GLOBAL TOPICS REPORT ON THE PRESTANDARD AND COMMENTARY FOR THE SEISMIC REHABILITATION OF BUILDINGS

**GLOBAL TOPICS REPORT ON THE
PRESTANDARD AND COMMENTARY FOR THE
SEISMIC REHABILITATION OF BUILDINGS**

**Prepared by
AMERICAN SOCIETY OF CIVIL ENGINEERS
Reston, Virginia**

**November 2000
Federal Emergency Management Agency
Washington, D.C.**

Figure 5:

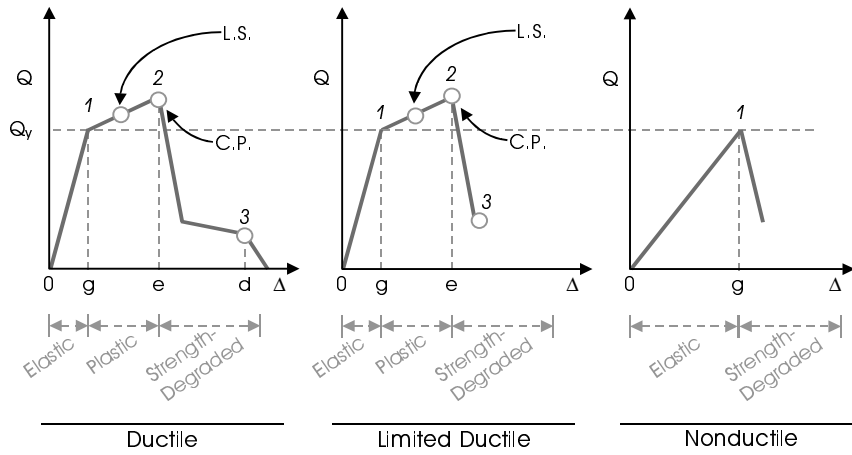
FEMA 273 acceptance criteria are set based on generalized component behavior curves corresponding to ductile, limited ductile or nonductile behavior. These curves, reproduced from FEMA 273, are shown in Figure 5. They are characterized by an elastic range, followed by a plastic range (with or without strain hardening), and finally a strength-degraded range. For ductile behavior the strength-degraded range includes significant residual strength. Nonductile behavior has no plastic range and little residual strength.

Using the curves in Figure 5, acceptance criteria for primary elements is set at point 2 for the Collapse Prevention Performance Level, and 75% of point 2 for the Life Safety Performance Level. As defined, the acceptance criteria limit the acceptable response of each component to the elastic or plastic regions of the idealized backbone curves. Primary lateral force resisting elements are not permitted to experience demands in the strength-degraded range. A building will fail the acceptance criteria as soon as the worst case primary element begins to degrade, which means that the overall structure is never permitted to experience degradation. This is not consistent with demands calculated presuming the presence of degradation and not consistent with the descriptions of damage used to distinguish between performance levels.

To establish an appropriate level of conservatism, this “double counting” should be eliminated. If demands are to be calculated presuming the components will degrade, the acceptance criteria should be consistently set permitting some level of degradation. The validity of this approach can be seen when considering the global behavior of a structure. Consider a four-story concrete shear wall structure with the pushover curve depicted in Figure 6. The curve was developed using components modeled with the full degrading backbone curves. Individual components were allowed to exceed collapse prevention acceptance criteria and slip into the degraded range of response. As can be seen by the curve, even as individual elements degrade, the overall structure maintains a stable level of resistance. The performance limit of the building is not reached until a significant number of components have had a chance to degrade.

Figure 6: Pushover Curve, Four Story Shear Wall (Building 9)

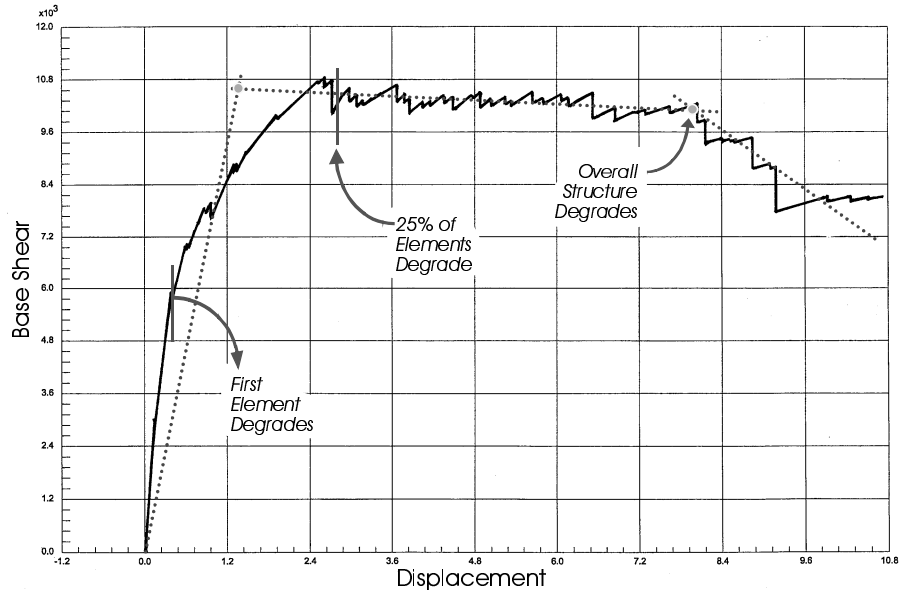
The proposed global acceptance criteria involves applying the concept of the idealized component backbone curve to the pushover curve of the entire structure. An example of this is shown in Figure 6. Global acceptance of the structure can be measured by selecting a performance point, such as the point where significant structural degradation occurs in Figure 6. Just as component acceptance criteria are set using the component backbone curve, the global performance levels can be set from the pushover curve as follows: CP – performance point; LS – 75% of the performance point; IO – 50% of the performance point. To draw the pushover curve, components are modeled using full backbone curves, including strength degradation and residual strengths, and are permitted to respond in the strength degraded range up to the current CP limits for secondary elements.

Figure 4-3 (a) Foundation Shape Effect (b) Foundation Embedment Effect

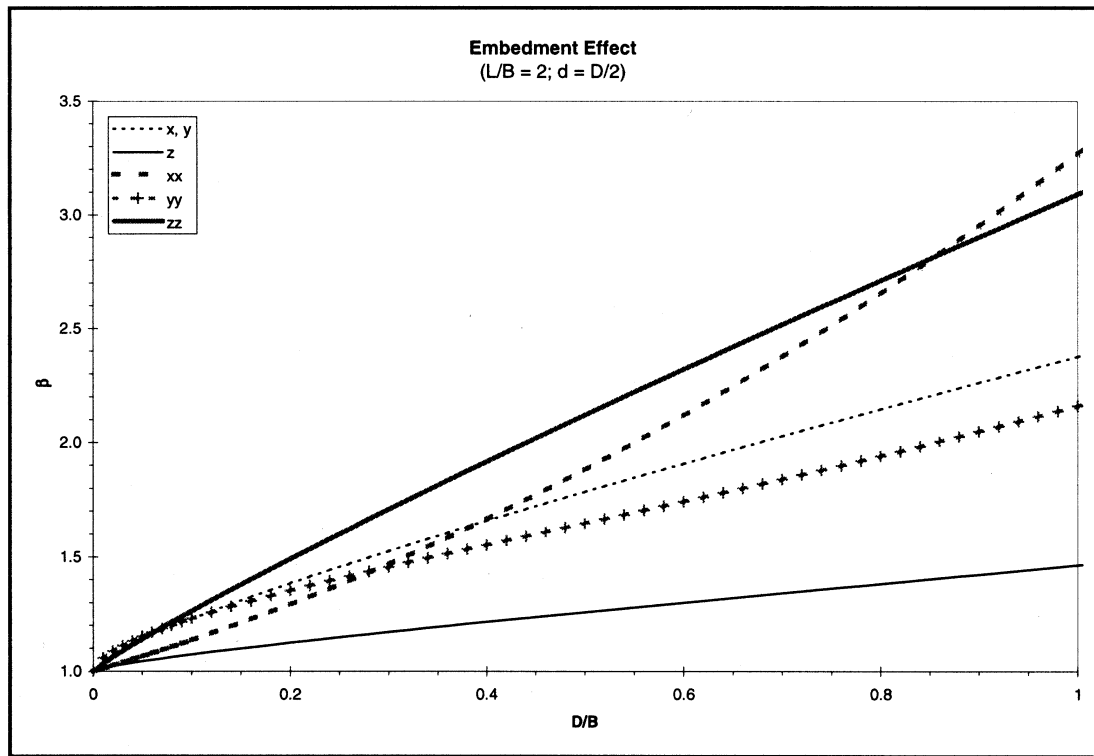
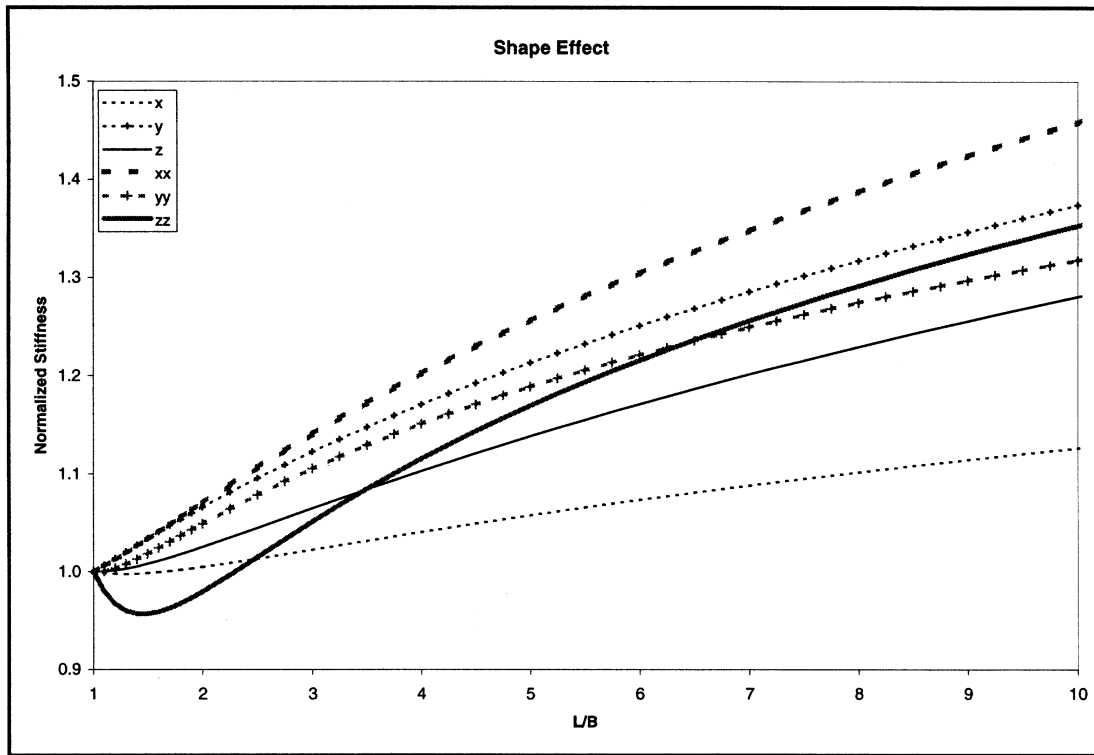
The original issue focuses on the applicability of the circular footing spring stiffness solutions to strip footings; the length to width aspect ratio in the current procedure (Figure 4-3a) is limited to a maximum of four. In the course of this project, it was also noted that the range of embedment reflected in the embedment correction factors (Figure 4-3b) is too small for most practical problems.

Resolution: Prestandard Figure 4-4 has been revised to include new equations for spring constants that are directly applicable to rectangular footings. Figure C4-1 is a graphical representation of information in the equations that has been added to the commentary for information only.

Figure 4-4 Passive Pressure Mobilization Curve

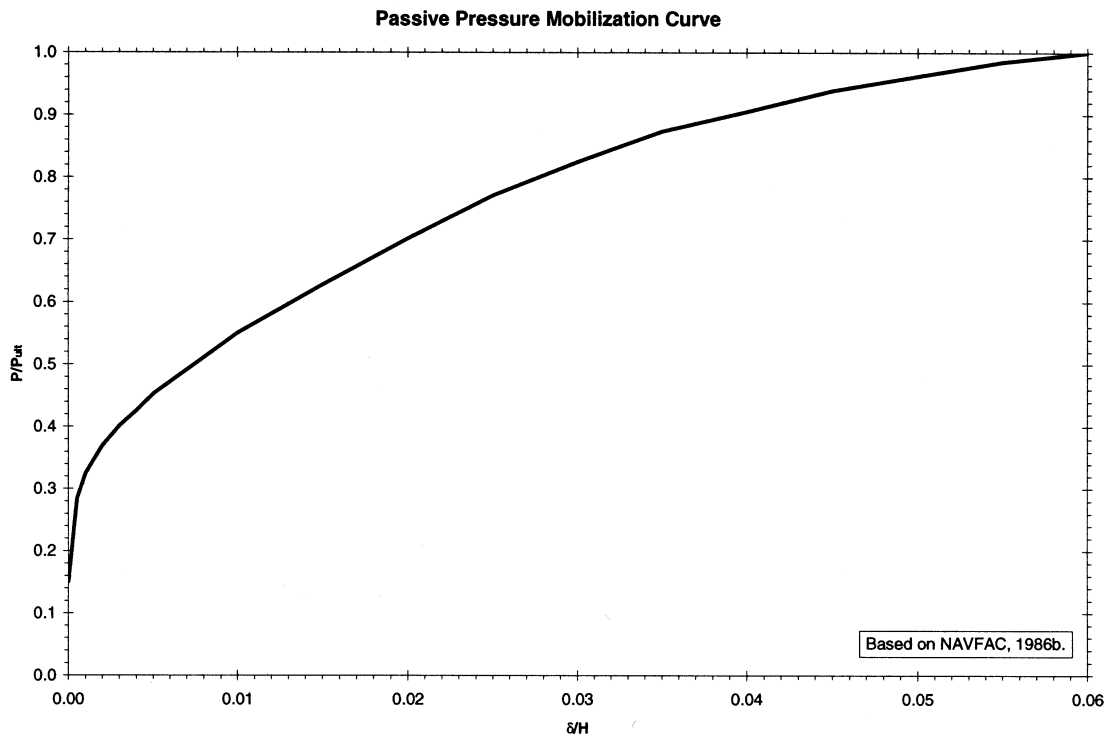
Discussion: Upon completion of the *Guidelines*, BSSC identified the need to conduct additional research on this issue. Special Study 4 – Foundation Issues was funded to research this issue further. The study concluded that the present linear relationship for passive pressure mobilization shown in *Guidelines* Figure 4-4 is unrealistic. The actual relationship is highly nonlinear.

Resolution: Prestandard Figure 4-6 has been revised to reflect the actual nonlinear relationship for mobilization of passive pressure.

Figure 4-x. Pile or Pier Capacities for Granular Soils (adapted from NAVFAC, 1986)

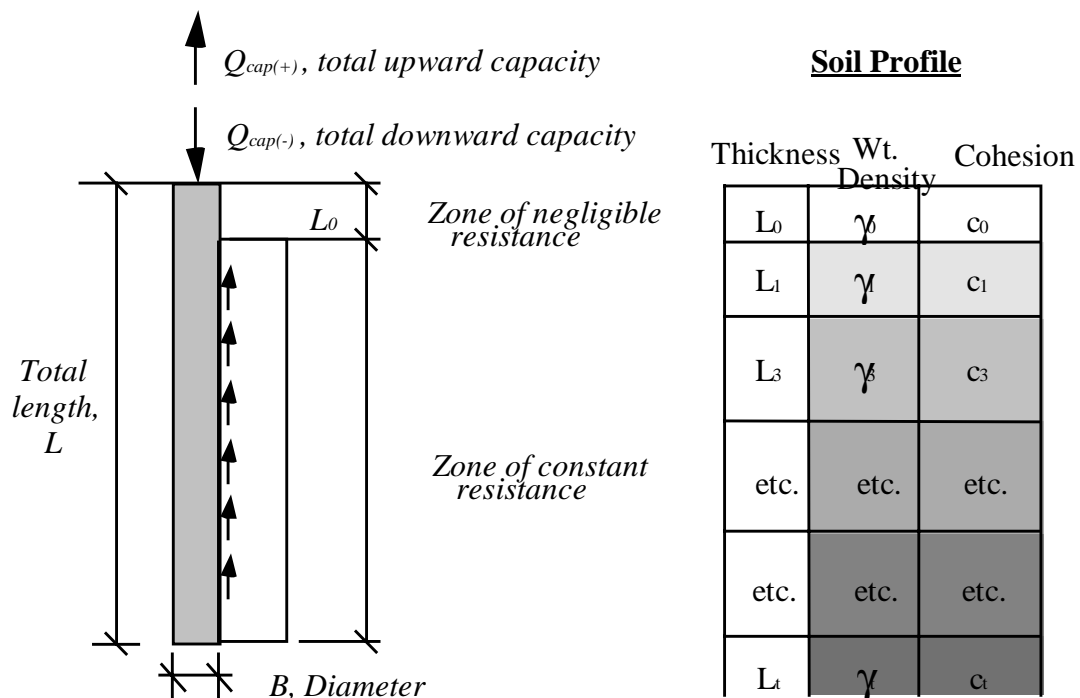
ATC11. Add presumptive capacities for piers and piles.

Figure 6-x: Identification of component types in wall elements (from FEMA 306(ATC, 1998a))

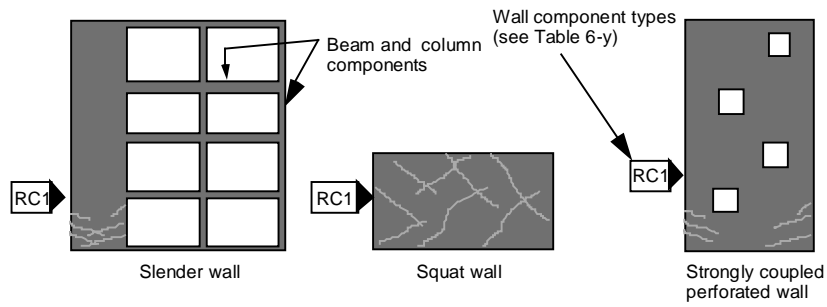
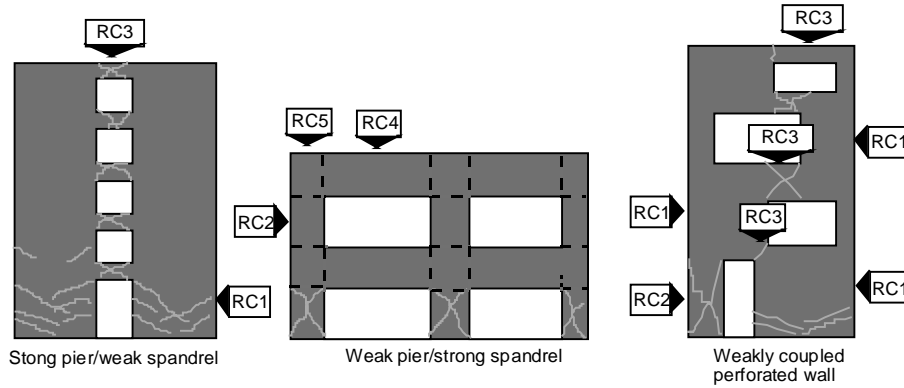
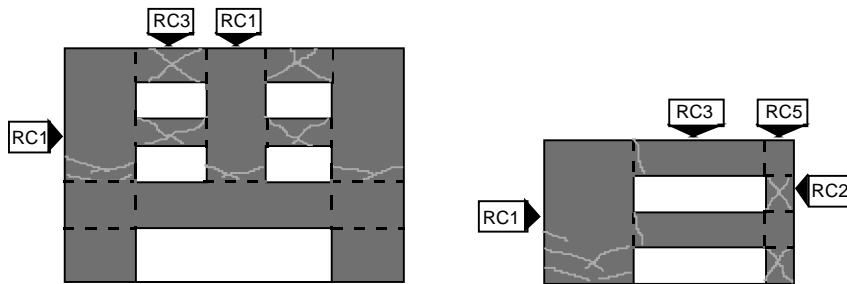
Suggested change: Add a paragraph C6.8.1.1.iii as follows:

“The identification of components in concrete shear wall elements depends on the relative strengths of the wall segments. Vertical segments are often termed piers, while horizontal deep beam segments are called coupling beams or spandrels. This concept is covered in FEMA 306 (ATC, 1998a) and ATC-40 (ATC, 1996). Typical components for concrete walls are summarized in Table 6-y from FEMA 306. A plastic analysis of the entire wall element as it is displaced laterally to form a mechanism can help to identify component types as shown in Figure 6-x.”

Figure 6-y: Component Modeling Criteria (from FEMA 306)

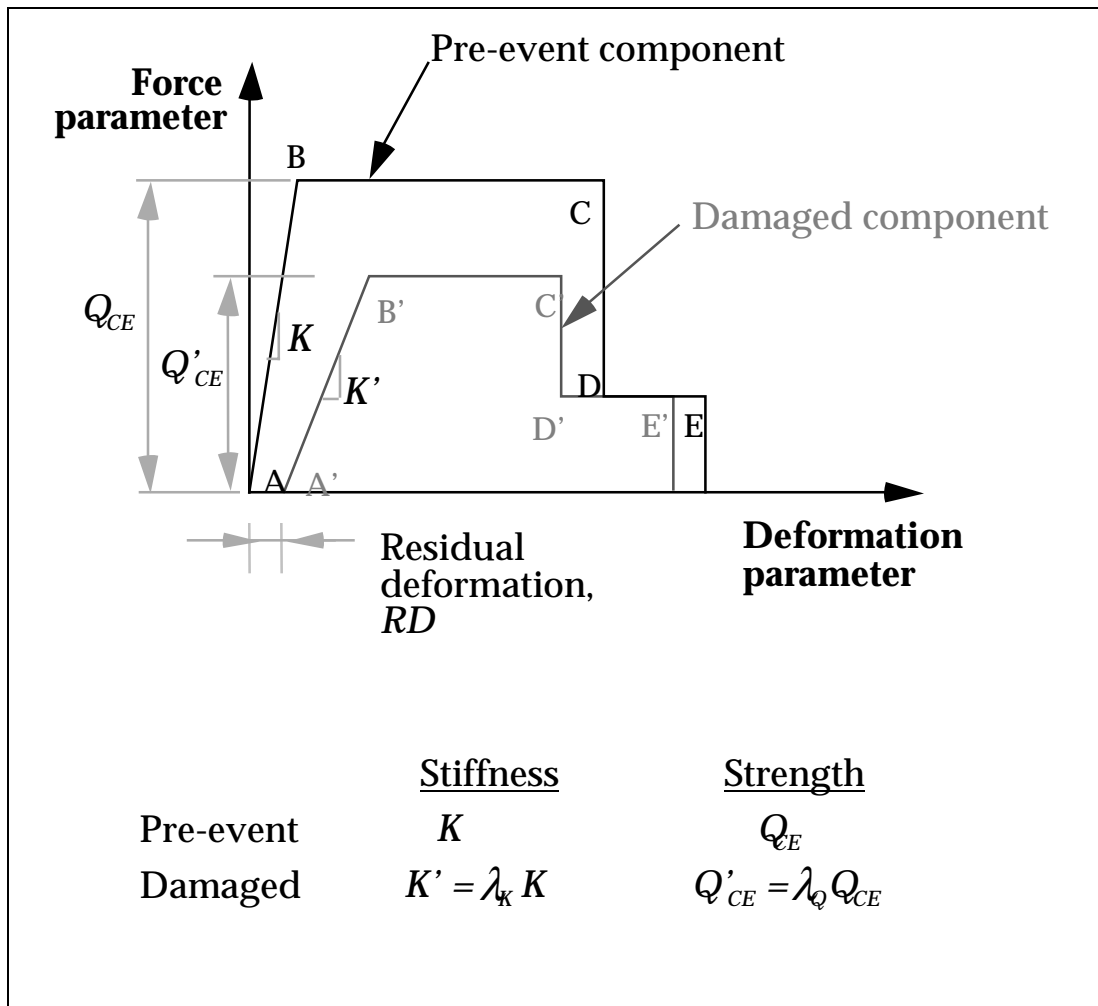
Add a paragraph C6.8.2.1.zz as follows:

“FEMA 306 and 307 (ATC, 1998a, b) contain extensive information on the properties and behavior of damaged concrete shear walls. Although developed for the purpose of evaluating earthquake damage, these documents can provide expanded information to address specific conditions encountered for individual buildings. The effects of damage on component behavior are modeled generically in Figure 6-y. Acceptability criteria for damaged components are illustrated in Figure 6-z. The factors used to modify component properties for observed damage range from 0.0 to 1.0 and are defined as follows:
